CNG Field Service Bulletin
Luxfer Cylinder Valve Torque Precaution
ENP-714
November 15, 2018

Luxfer OTV (One-Turn Valve) Model: MPVE-250

Topic: Over-Torque Prevention

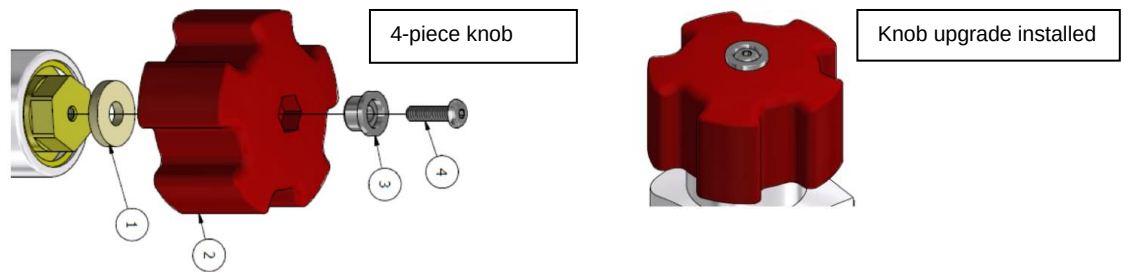
WARNING: Torques greater than the maximum specified are unnecessary and can damage the valve and in extreme over-torque cases might create unsafe conditions.

High over-torques can split the knob into 2 or 3 pieces. A cracked or split knob does not affect valve sealing; however, it indicates excessive torque applied to the knob. Replace a cracked or split knob immediately.

A. Knob Upgrade

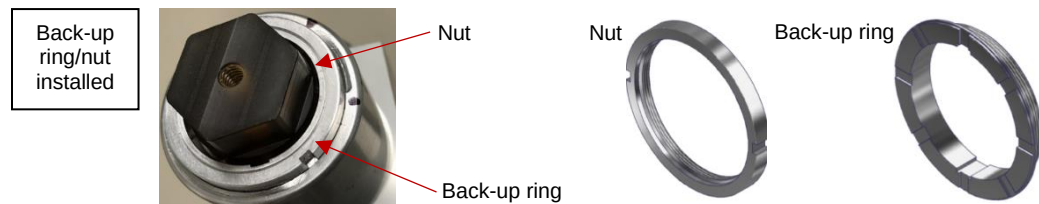
The knob upgrade has 4 pieces (see below left). It raises the knob $\sim \frac{1}{8}$ " and slightly changes the appearance of the top of the knob (see below right). This knob is stronger and more difficult to turn with a tool.
